Serial No.: 10/024,573  
Attorney Docket: 178/50688

### REMARKS

*Approved  
C. L. L.***Fig. 1(a)**

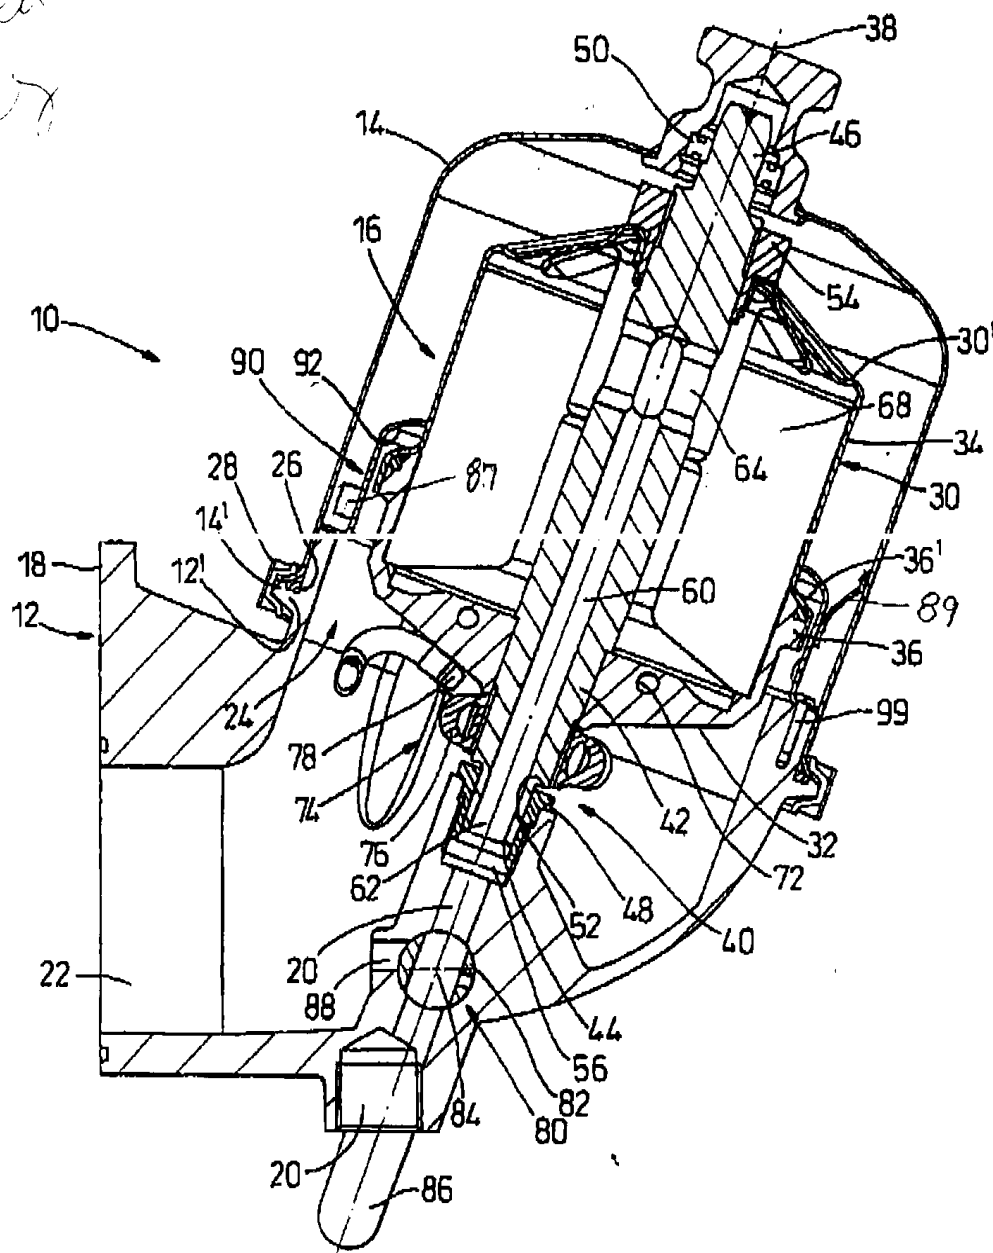
In the Office Action, the drawings were objected to for not showing the warning means, the means responsive to the presence of the abutment, and the interlock means. Applicant has added the warning means and the means responsive to the presence of the abutment to Figure 1(a). Applicant has also added a new figure (Figure 1(c)) to show the interlock means. As a result, the drawing objections are overcome.

The Examiner has also indicated claims 13 and 14 would be allowable if the drawing objections are addressed. Applicant has addressed the drawing objections by amending Figure 1(a) and adding Figure 1(c). Therefore, claims 13 and 14 are allowable.
